> Re: Application of Champlain Hudson Power Express, Inc. for a Certificate of Environmental Compatibility and Public Need Pursuant to Article VII of the Public Service Law for the Construction, Operation and Maintenance of Two 1,000 MW High Voltage Direct Current Circuits from the Canadian Border to <u>New York City and Bridgeport, Connecticut</u> Case 10-T-0139

Case 10-T-0139

Response to the New York State Department of Public Service Visual Assessment Information Needs Request

Photo 1. This is a view of the Project area from the north side of the pier at the Alpine Picnic Area and Boat Basin located on the New Jersey side of the Hudson River. This view is approximately 1.1 miles

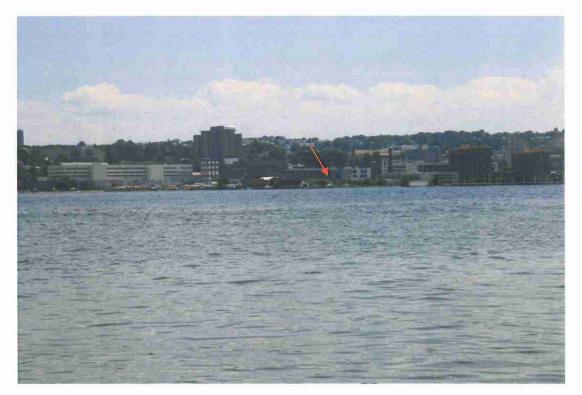
Comment 1b ... DPS identified significant resources at foreground, middle ground and near background distances along Hudson River that warrant additional evaluation and representation in visual assessment.

From Photos 1 and 2, one sees an urban waterfront. Although there is a mix of building heights and sizes and industrial/commercial land uses, the waterfront development in a direct line of site from the camera location to the proposed facility is low enough to indicate that there will be views of the facility. From a further distance such as this location, one can see the homogeneity that the brick buildings bring to the view, and that the lighter inconsistent building materials of several of the other buildings give contrast. The selection of an appropriate color for building materials will assist in lending to some of the existing homogeneity.

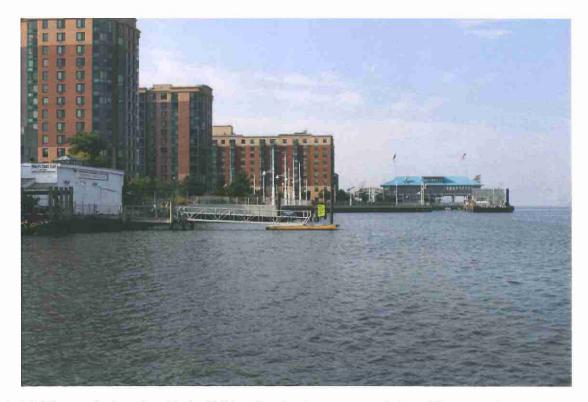
Comment 2. The report should address appearance and potential viewing opportunities from public vantages for cable marking signs at landfall locations.

Response 2. CHPEI has prepared conceptual warning signage for the cable landfall location at Yonkers noted below.

Representative signage in the conceptual stage. This sign as represented in Photos 14 and 15 has an 8'x8' mounted dimension. Figure 2 shows the cable landfall location at the western end of Wells Avenue.
